# Longwood gate, Longwood, Huddersfield

Technical Note

September 2025

DRAWING TITLE  
VISIBILITY & SPA DRAWING

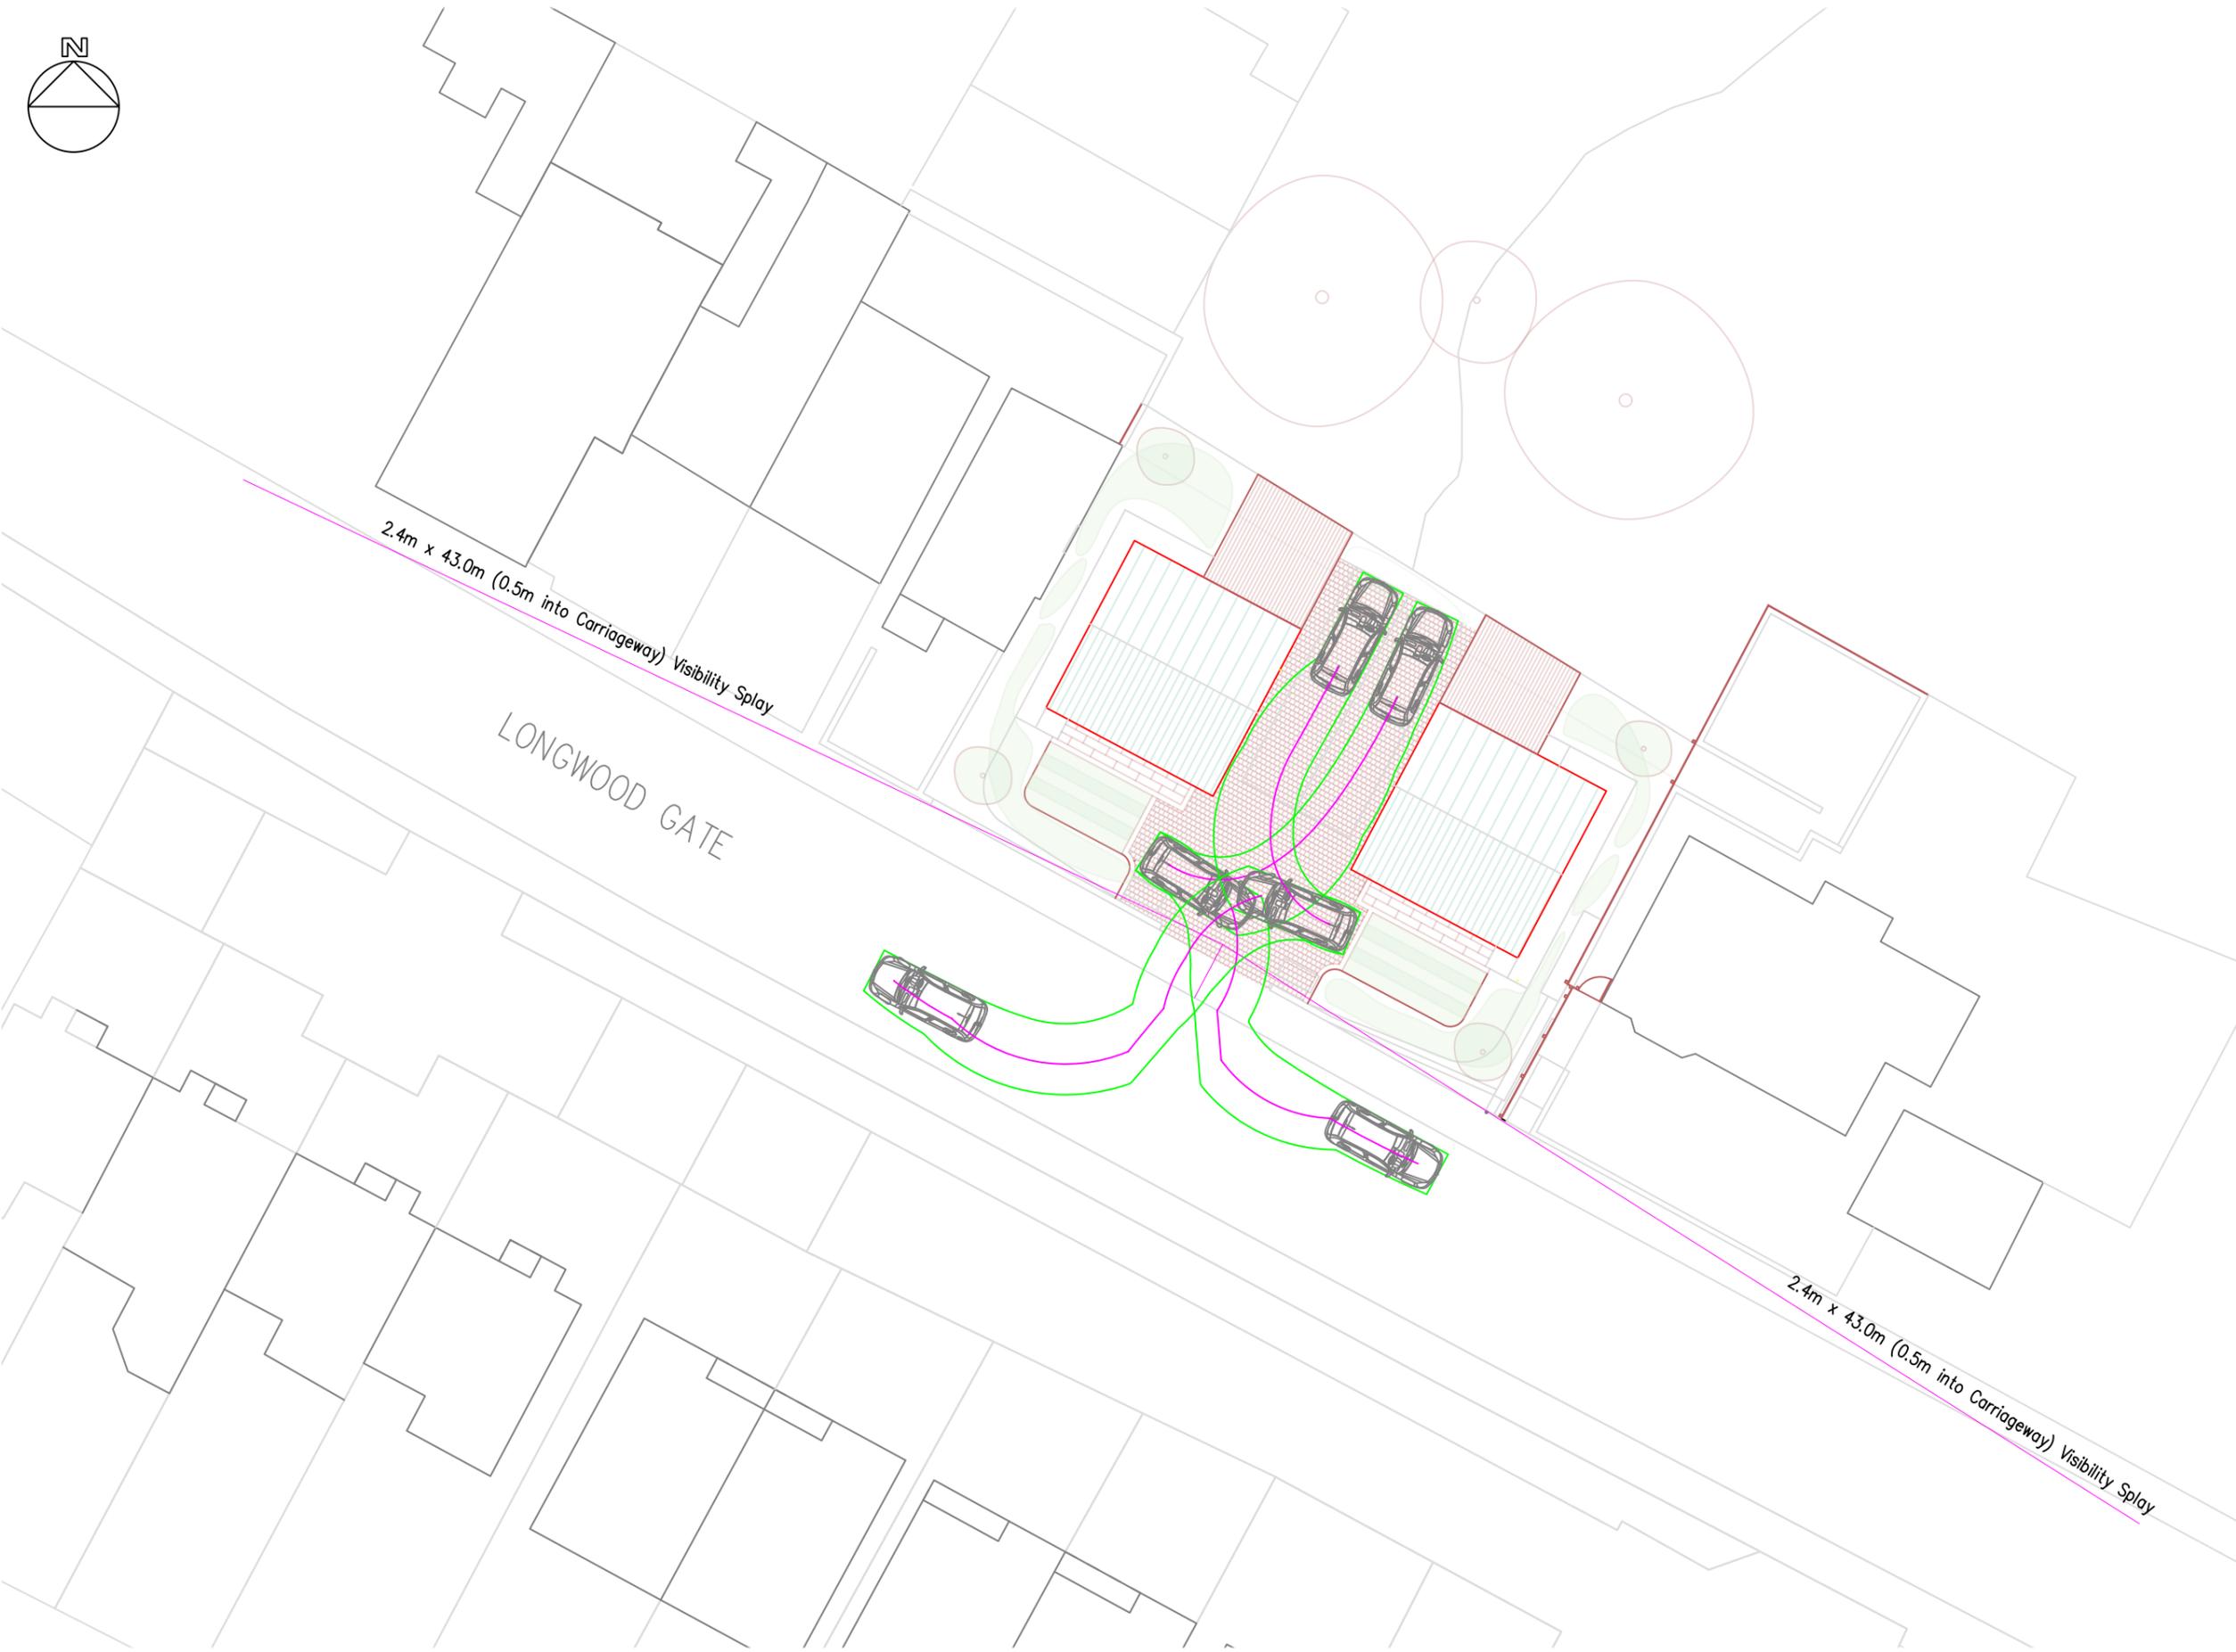
- *There is reference to 'Low level stone wall to match existing with opening onto highway providing visibility splays as Highway engineer detail' on drawing (24311)12\_Scheme as proposed Elevations rev C. Can this detail be provided as it does not appear to be confirmed in any of the other submitted plans / documents.*
- *Visibility is sub standard for a 30 mph road, the submitted plans indicate sightlines of 2.4 x 39.1 and 38.1 respectively. Please can any points considered to be justification of the shortfall of required visibility be set out.*
- *No swept paths to determine if vehicles can enter and exit the site in forward gear have been provided, please can these be submitted.*

- 2.1 Kirklees Council has raised concerns regarding the visibility splays at the proposed access. The previously submitted drawings indicated visibility splays of 2.4m x 39.1m and 38.1m to the nearside kerb line respectively, which were considered substandard against the requirement for a 30mph road. Manual for Streets (MfS) guidance sets the desirable minimum 'Y' distance at 43.0m for a 30mph road.

- 2.2 A further assessment has been undertaken and demonstrates that 2.4m x 43.0m is achievable in both directions when the splays are measured to the nearside wheel track rather than to the kerb line. Section 10.5.3 of Manual for Streets 2 supports this methodology, stating:

- 2.3 This approach therefore represents a robust and policy compliant assessment. The drawing provided at Appendix A demonstrates the achievable visibility splays of 2.4m x 43.0m, measured 0.5m into the carriageway, which accord with MfS requirements for a 30mph road.

- 2.4 To maintain these sightlines, the proposed boundary wall and any planting or structures within the visibility envelope will be limited to a maximum height of 1.0m above carriageway level. This ensures that the splays remain unobstructed at all times.

- 2.5 Swept path analysis has been undertaken using a private car to confirm that vehicles can safely enter the site, manoeuvre within, and exit onto the highway in a forward gear. A small turning area is provided to the front of

both properties, which enables vehicles to reverse from the parking bays and complete the manoeuvre without reliance on the public highway.

- 2.6 The results of this assessment are illustrated on the plan at Appendix A, which clearly demonstrates that vehicles can enter and exit the site in a safe and convenient manner.
